## Technical Service BULLETIN

**M.I.L. "ON" DTC P0031 AND/OR P2238**

**'04 RAV4**

ENGINE  
EG036-04

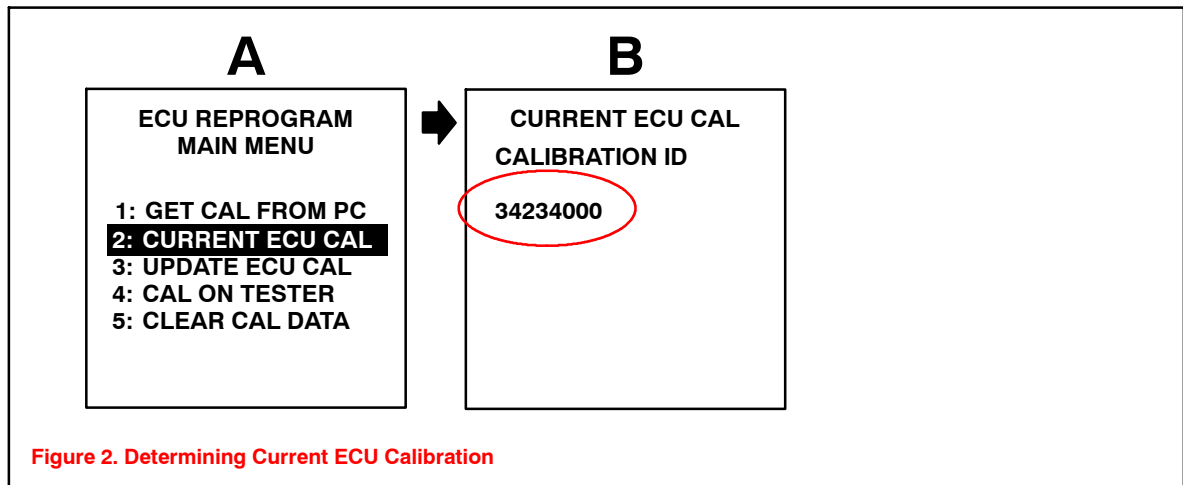
1. Check for the Authorized Modifications Label affixed to the vehicle in the location shown in Figure 1. Confirm if ECM (PCM) calibration has been updated. If not the latest ECM (PCM) calibration - **go to step 2.**

1. Follow the procedures outlined in TSB No. SS002-01, "ECU Flash Reprogramming Process," and flash the ECM (PCM) with new calibration file update.
2. Enter the required information on the Authorized Modifications Label and affix it to the vehicle at the location shown in Figure 1 (page 3). The Authorized Modifications Label is available through the MDC, P/N 00451-00001-LBL.
3. Calibration update is complete.
